ADDENDUM NO. CC-3

TELEGRAPH DISTRICT  
401 BUILDING RENOVATION  
LINCOLN, NEBRASKA  
DLR GROUP PROJECT NO. 10-16202-00

COMBINED CONTRACT

March 21, 2016

**PENTHOUSE FRAMING PLAN**  
SCALE: 1/8" = 1'-0"

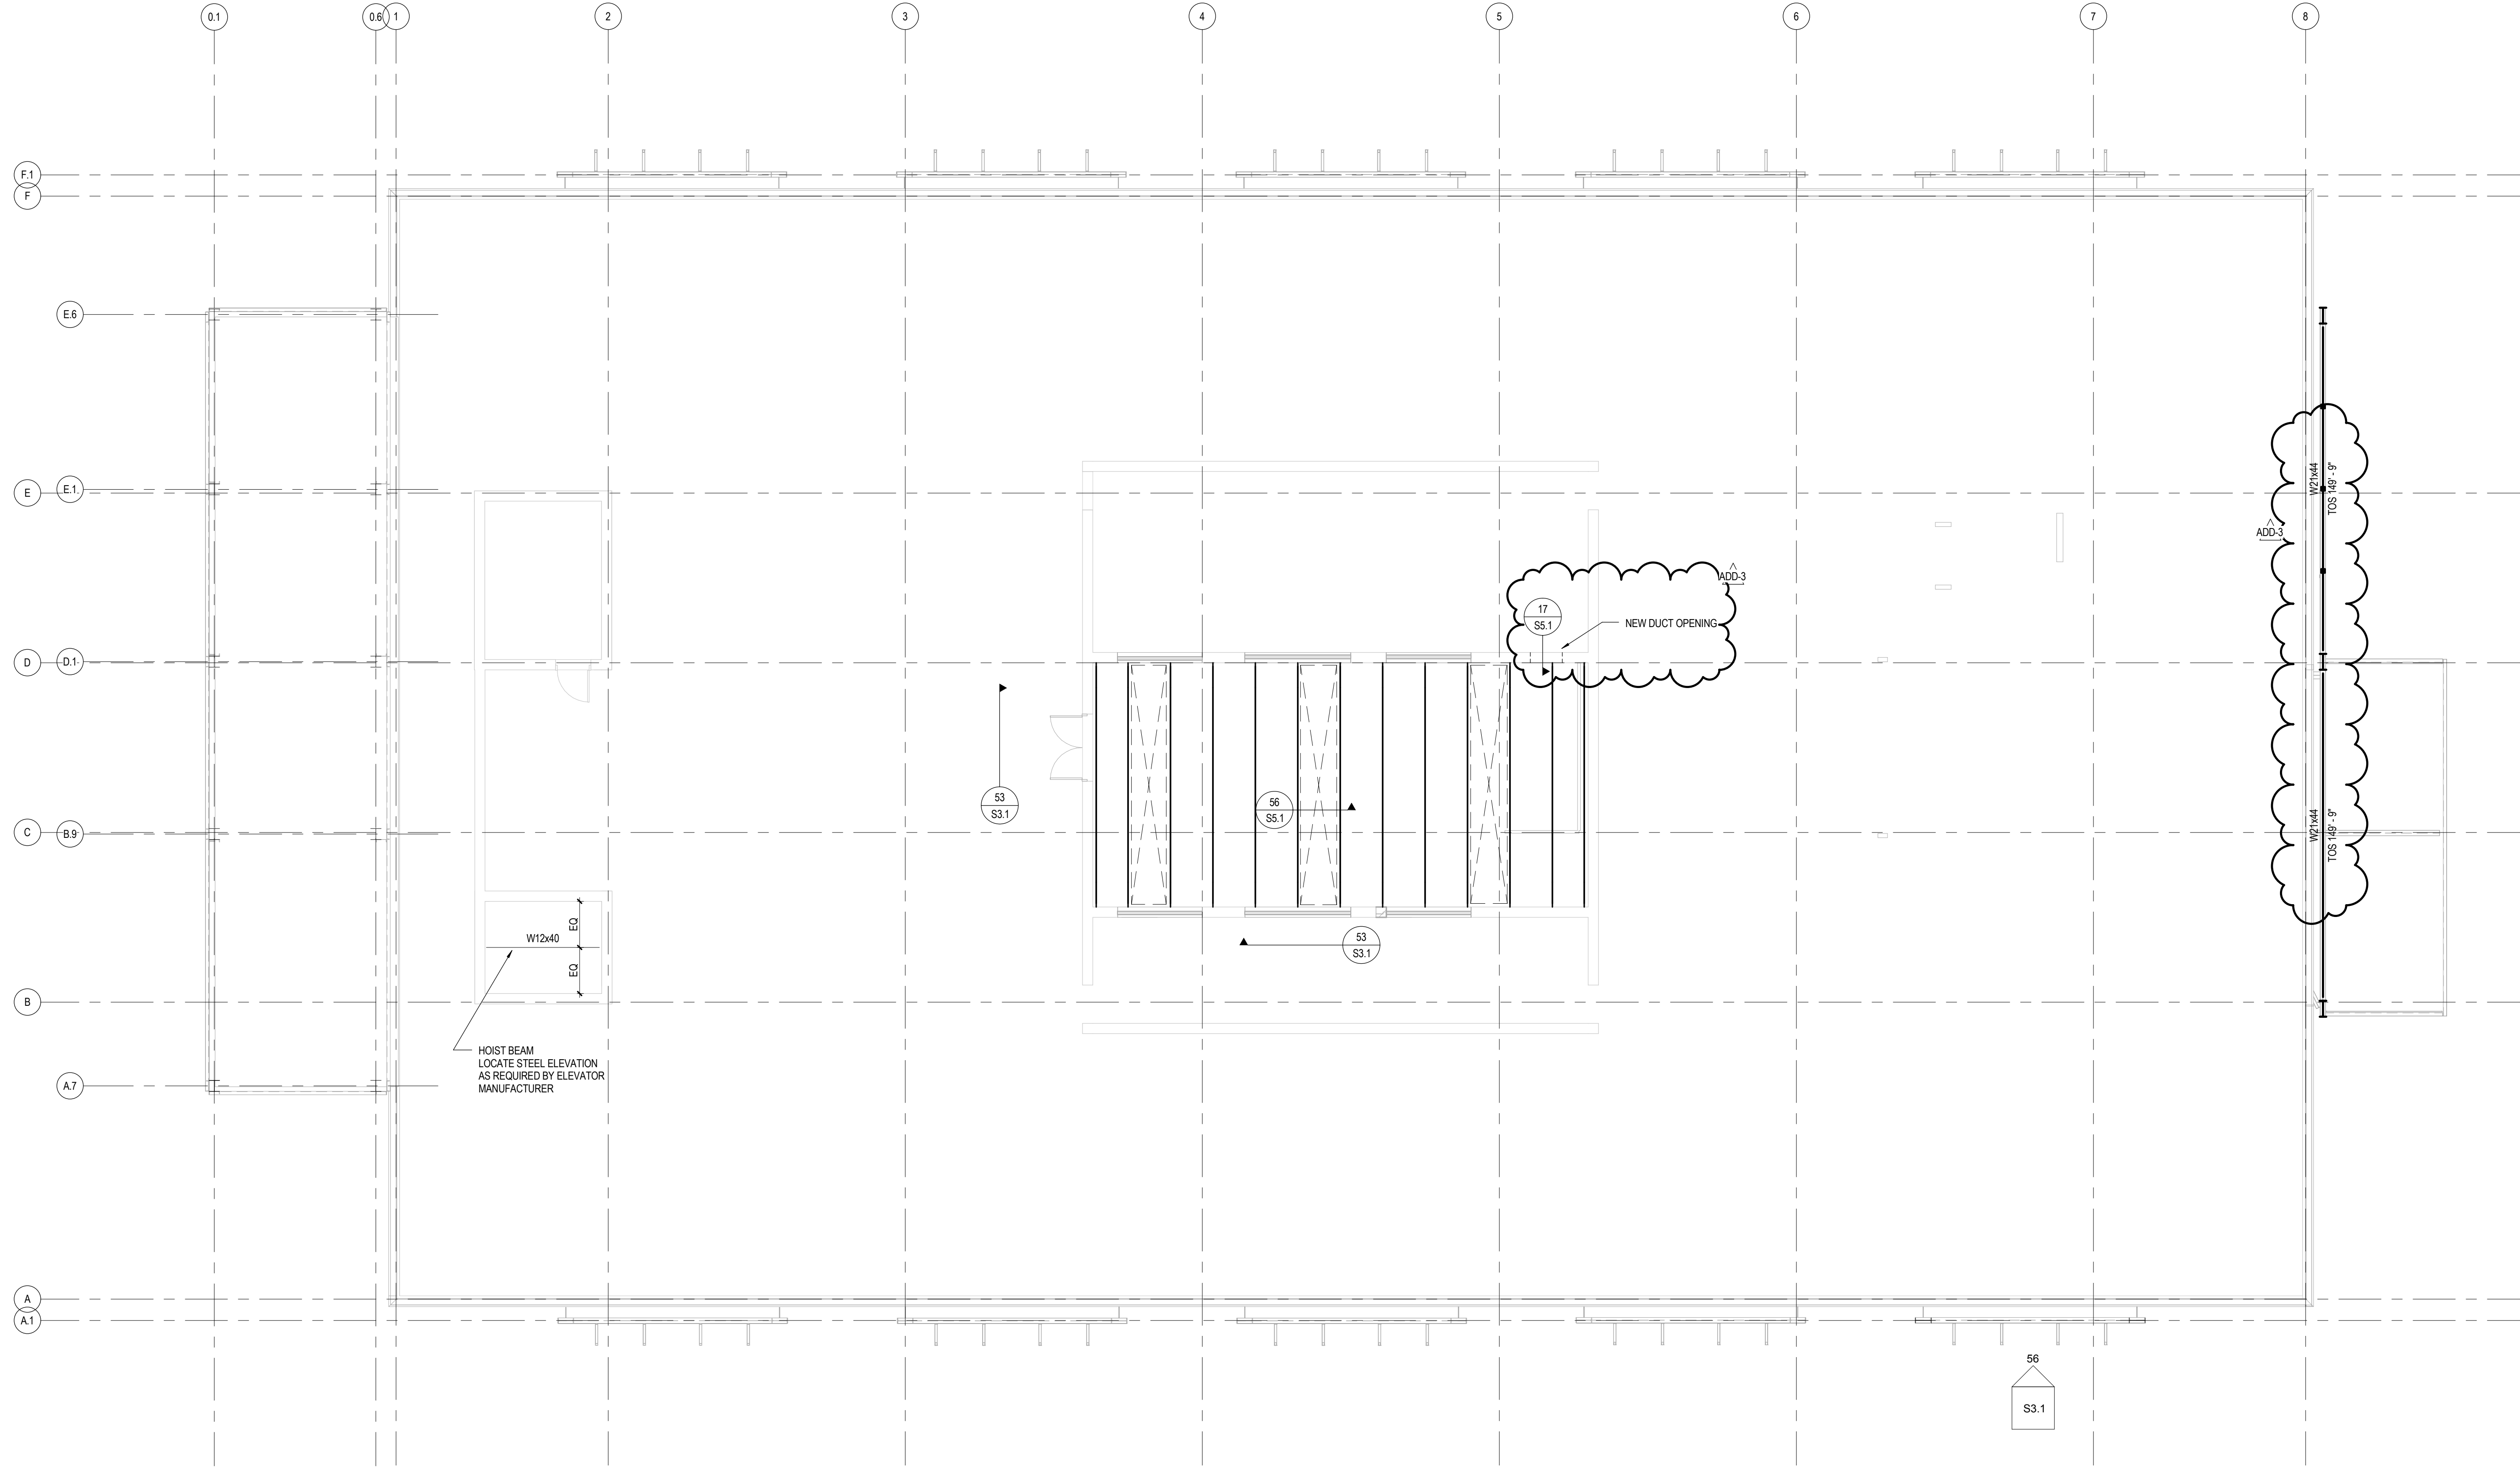
ITEM NO. 6 DRAWING S2.5 ROOF FRAMING PLAN - PENTHOUSE

- A. Modify drawings as shown on Attachment S2.5-1.
